**Safety Evaluation Report for
Rare Element Resources Inc.
Proposed Demonstration Plant
Upton, Wyoming**

Materials License No. SUA-1603

Docket No. 040-38415

July 2023

Figure 2. Example alpha detector source calibration curve with the applicant's Po-210 calibration source added (adapted from Figure A-1 in NUREG-1507)

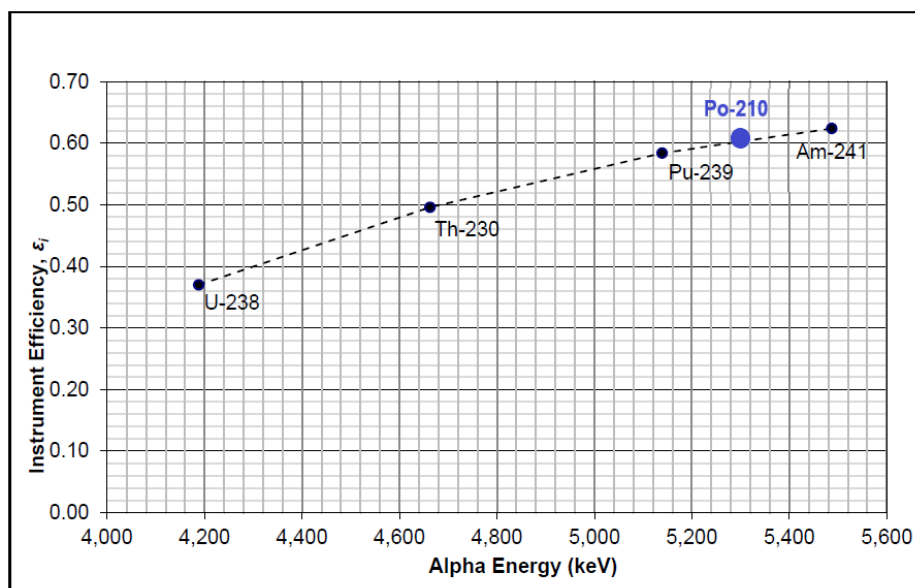
particle energies in Table 7 for the U-238 decay series. The NRC staff notes that the U-238, U-234, Th-230, and radium-226 (Ra-226) alpha particle energies are all below the Po-210 5.3 MeV alpha particle energy. Consistent with the guidance in NUREG-1507 (see the example in Table A-3), the instrument efficiency would be assigned zero for the U-238, U-234, Th-230, and Ra-226 alpha particles.

The applicant has the option of either choosing a lower energy calibration source or calculating a calibration curve with multiple alpha energy calibration sources. A typical calibration curve is demonstrated in Figure 2. Actual alpha particle calibration curves for different alpha detection instruments are shown in Figures A-5 and A-11 of NUREG-1507 and have the same characteristics (i.e., higher instrument efficiency for higher energy alpha particles). The applicant did not address how this difference in energy response will be addressed in its calibration program.

Based on the information submitted by the applicant in the September 2022 TR (RER, 2022a), the NRC staff could not conclude that the proposed method for determining instrument efficiency for use in calculating the MDC for comparison to surface contamination release limits would meet the requirements in 10 CFR 20.1501(c). Therefore, in RAIs (NRC, 2023), the NRC staff requested that the applicant provide justification and additional discussion regarding the use of Po-210 as the only calibration source for determining instrument efficiency for alpha particles.

In its response to the RAI (RER, 2023b) the applicant committed to working with the instrument manufacturer to calculate a calibration curve with multiple alpha energy calibration sources rather than move forward with the proposed single point calibration reference using Po-210. The applicant agreed to develop this calibration curve similar to the examples provided in the NRC's

Based on the applicant's response to the RAI (RER, 2023b), the NRC staff determined the proposed approach of using multiple alpha energy calibration sources rather than the single point calibration using Po-210 meets the intent of the requirements and will follow-up on the development and implementation of this proposed program for alpha calibration to support surveys as part of the pre-operational inspection required in LC 13, before the applicant will be authorized to conduct operations.

Figure 5. Nearest residents (label A) and proposed public exposure monitoring location (label B) at Demonstration Project [adapted from Figure 6 in the applicant's Technical Report (RER, 2022a)].

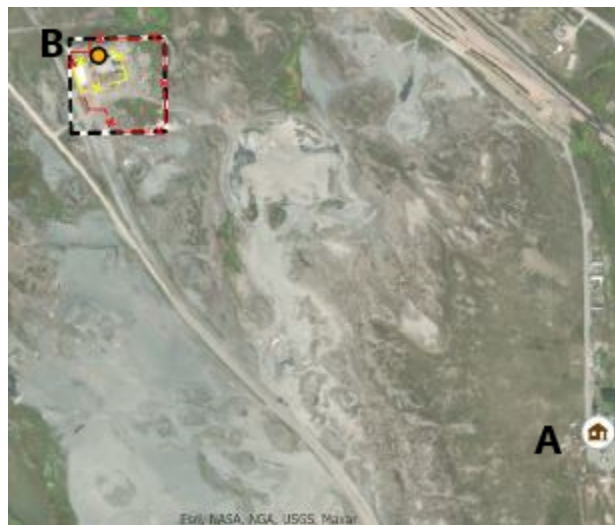
The applicant indicated the nearest residents were located as shown in Figure 5 below (label A). The nearest resident (label A) is approximately 1.2 kilometers (km) (0.75 miles (mi)) from the proposed public exposure monitoring location.

In its response to the RAI (RER, 2023b), the applicant agreed to add the additional locations identified by the NRC and committed to reviewing and updating the public dose analysis prior to the start of operations to verify that the identified resident was the individual likely to receive the highest public dose from licensed operations using methodology consistent with 10 CFR 20.1302 and NUREG-1736 Section 3 as detailed above.

Figure 6. Google Earth Pro representation of Upton wind rose and Demonstration Project [adapted from Map 4 in the applicant's ER (RER, 2022a)].

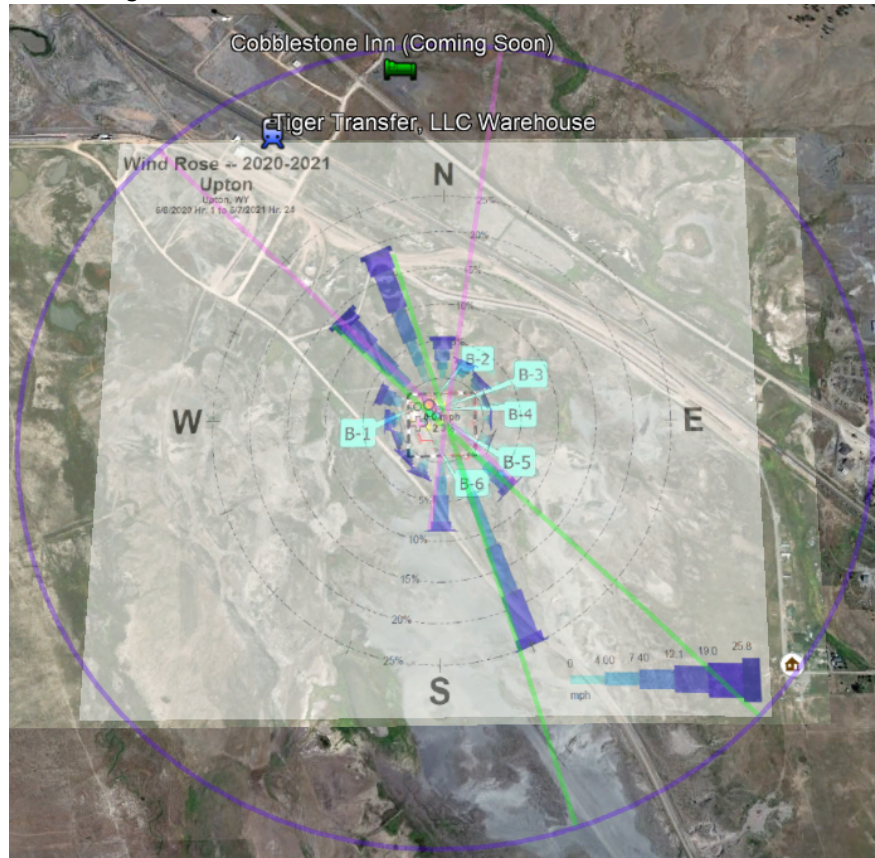
The NRC staff used Google Earth Pro to visualize downwind sectors based on a wind rose provided by the applicant (Figure 10 in the ER (RER, 2022a)). The wind rose and downwind sectors are shown in Figure 6 below.

The NRC staff also evaluated other potential receptors in the area near the Demonstration Project that could be located downwind from the facility. The NRC staff identified two additional potential receptors. Tiger Transfer, LLC appears to be an operating business and the Cobblestone Inn appears to be a business in the construction phase. Both of these locations appear closer in distance to the Demonstration Project than the nearest residents identified by the applicant. In the RAIs (NRC, 2023), the staff requested from the applicant justification for not using either of these two identified businesses for public dose.

Moreover, in addition to demonstrating regulatory compliance, the applicant has committed to verify that the dose estimate for an individual at the nearby businesses is bounded by that of the nearest resident. As reflected in LC 13, this updated public dose assessment is to be completed and provided to the NRC prior to, or as part of, the NRC’s pre-operational inspection. This additional license condition adds additional assurance that the dose assessment will be based on the maximally exposed individual.
